The Commission has issued the enclosed Amendment No. 10 to Facility Operating License No. DPR-31 and Amendment No. 9 to Facility Operating License No. DPR-41 for Turkey Point Nuclear Generating Units 3 and 4. These amendments include Change No. 22 to the Technical Specifications and are in response to your request dated September 19, 1974, as supplemented January 9, 1975.

TURKEY POINT NUCLEAR GENERATING UNIT 3

Amendment No. 10
License No. DPR-31

ATTACHMENT TO LICENSE AMENDMENTS NOS. 10 AND 9
CHANGE NO. 22 TO THE TECHNICAL SPECIFICATIONS
FACILITY OPERATING LICENSE NOS. DPR-31 AND DPR-41
DOCKETS NOS. 50-250 AND 50-251

OFFSITE ORGANIZATION CHART
FIGURE 6.2-1

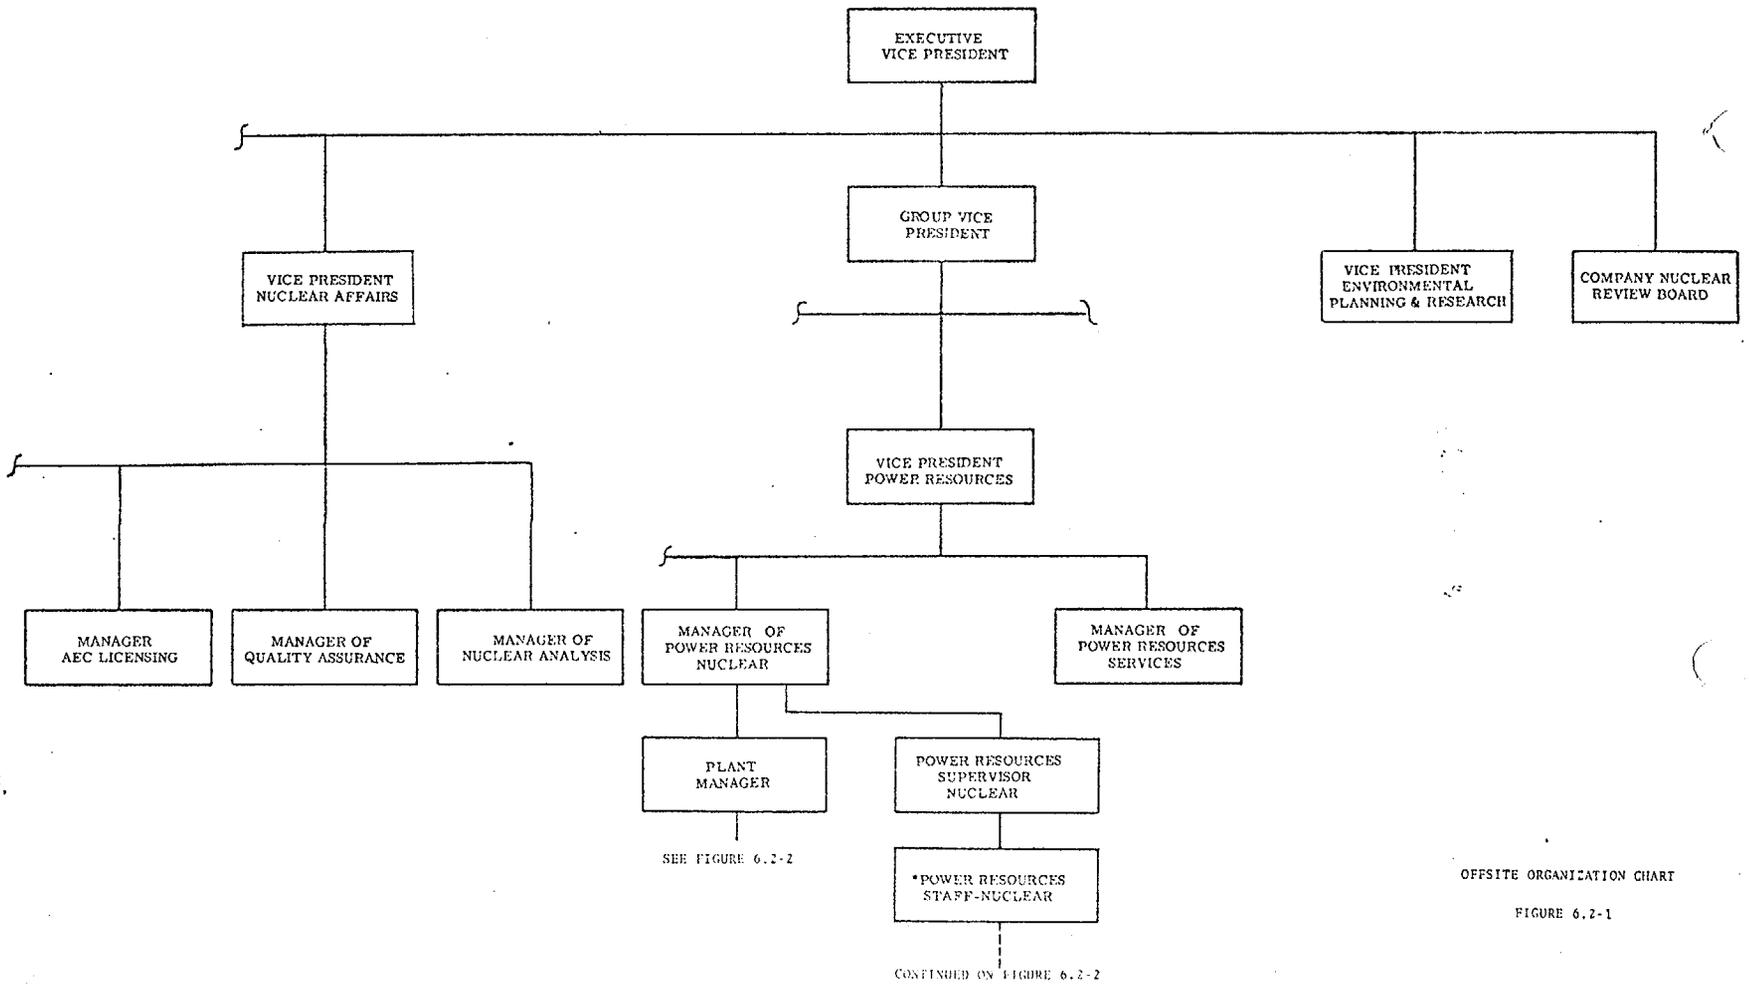
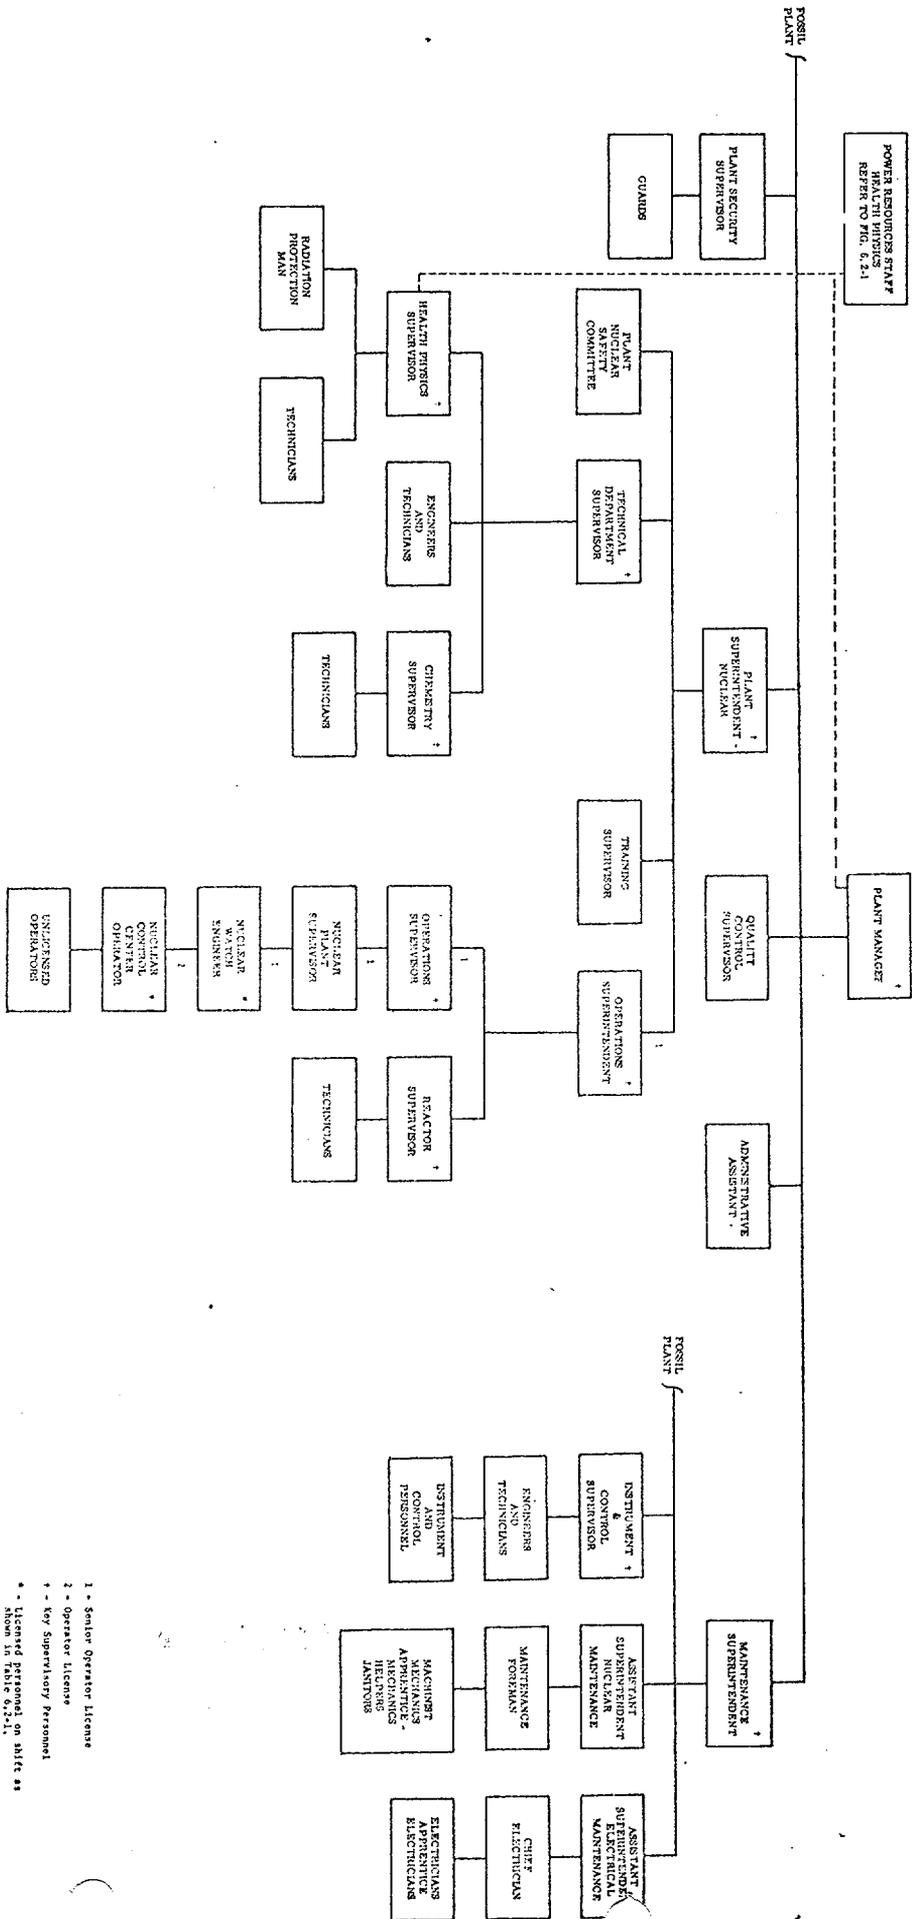
These amendments incorporate in the Technical Specifications a revised Administrative Controls Section except for that portion relating to the reporting requirements which is still under review.

Figures 6.1-1
6.1-2
6.1-3

The offsite organization for facility management and technical support shall be as shown on Figure 6.2-1.

The Facility organization shall be as shown on Figure 6.2-2 and:
